## A. Affected Silicon Revision

**netX500, Revision A (Step A, ROM Rev. 0, Boot loader major vers. 0x41)**

## B. Document Revision History

### C. Errata Summary

# Summary of 10BT problem on EthernetPHY

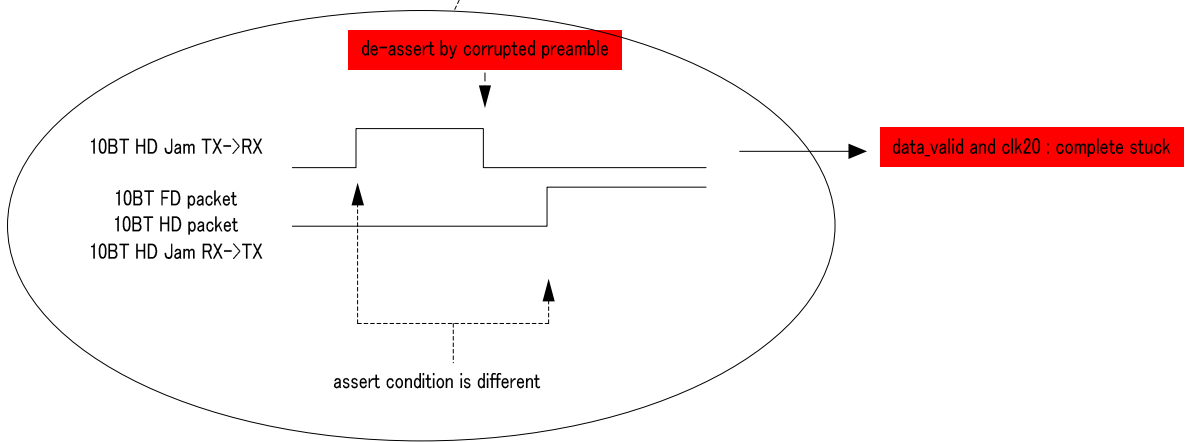
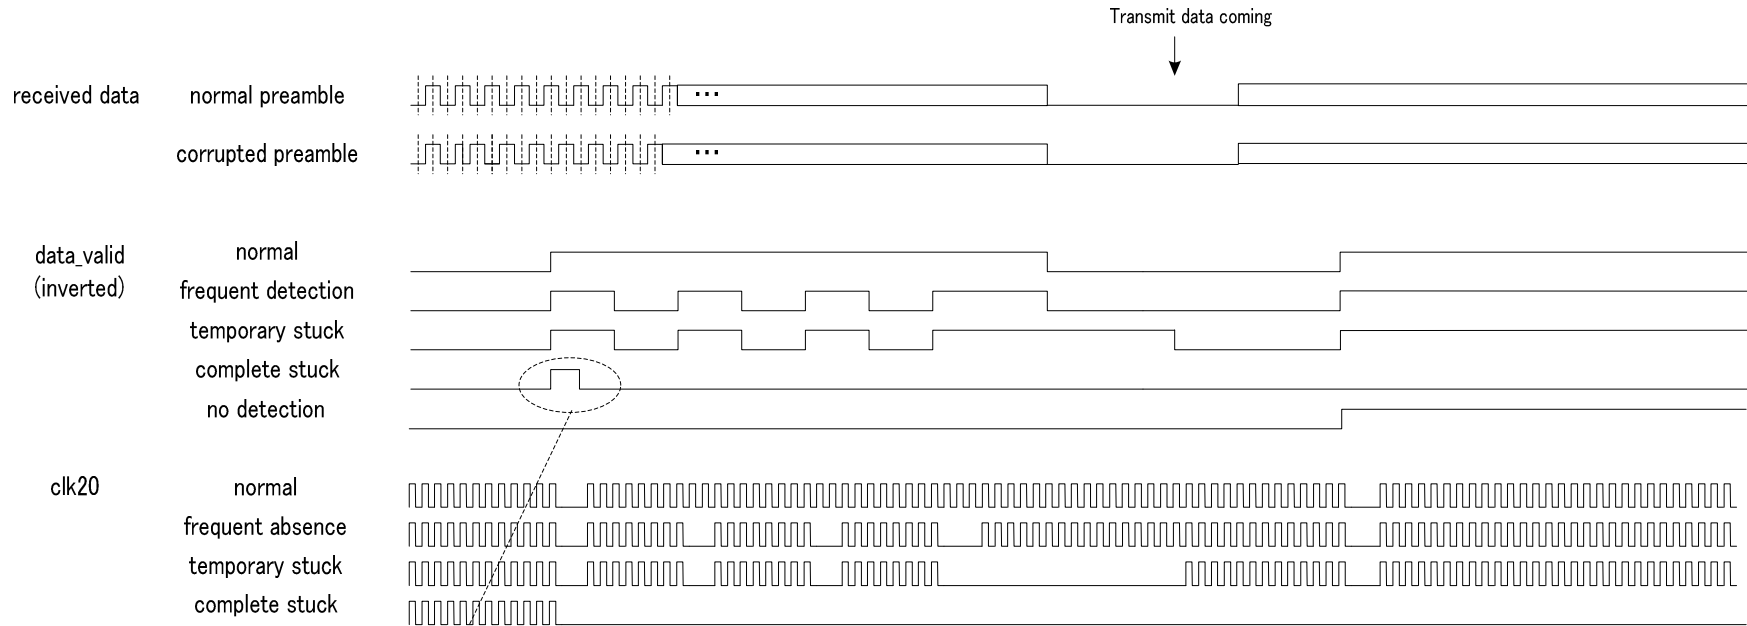
- Illegal behaviour of COL signal during 10baseT half duplex collision
  - RX immediately follows to start TX
- PHY get stuck while in 10BaseT
  - Statistical behaviour
  - Depending on IPG

cause of problem		possibility of problem	
		received data	async on preamble filter	data_valid (crs of receiver)	clk20
10BT HD	Jam RX->TX (collision)	normal preamble	OK	normal	normal
		normal preamble	NG	normal / no detect / frequent detection	normal /frequent absence
		corrupted preamble	OK	normal	normal
		corrupted preamble	NG	normal / frequent detection	normal / frequent absence
	Jam TX->RX (collision)	normal preamble	OK	normal	normal
		normal preamble	NG	normal / no detect / frequent detection / temporary stuck	normal / frequent absence / temporary stuck
		corrupted preamble	OK	normal / complete stuck	normal / complete stuck
		corrupted preamble	NG	normal / complete stuck	normal / complete stuck
	Packet	normal preamble	OK	normal	normal
		normal preamble	NG	normal / no detection	normal
		corrupted preamble	OK	normal	normal
		corrupted preamble	NG	normal / no detection	normal
10BT FD	Packet	normal preamble	OK	normal	normal

normal preamble	NG	normal / no detection ※1	normal
		corrupted preamble	OK	normal	normal
		corrupted preamble	NG	normal / no detection ※2	normal

※1 There is no discarded packet when we observed in Labo. (163.8Mpackets)

The problem doesn't occur as long as one preamble is detected during all preamble pattern(56BT).

※2 Currently we found no equipment to generate corrupted preamble in 10BT FD mode.
